UNITED STATES PATENT AND TRADEMARK OFFICE

Advisory Action

Application No.	Applicant(s)	
09/614,154	EDWARDS, MARTIN J.	
Examiner	Art Unit	
Leonid Shapiro	2677

FIG. 2

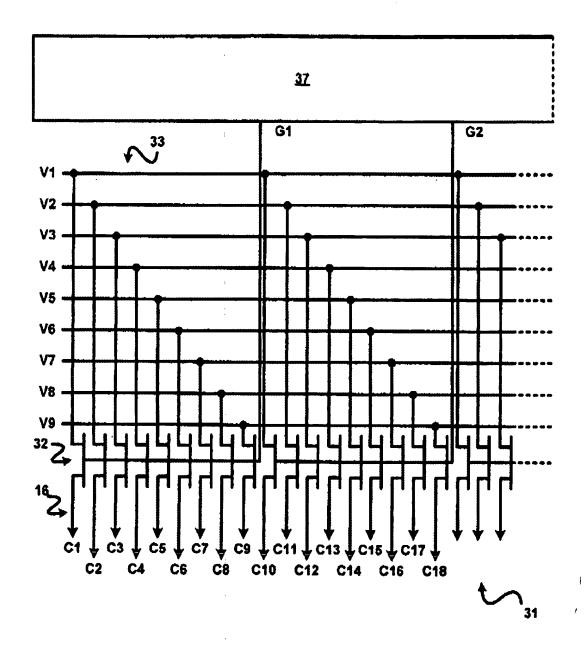
OK. to enter 1.5. 01.23.06
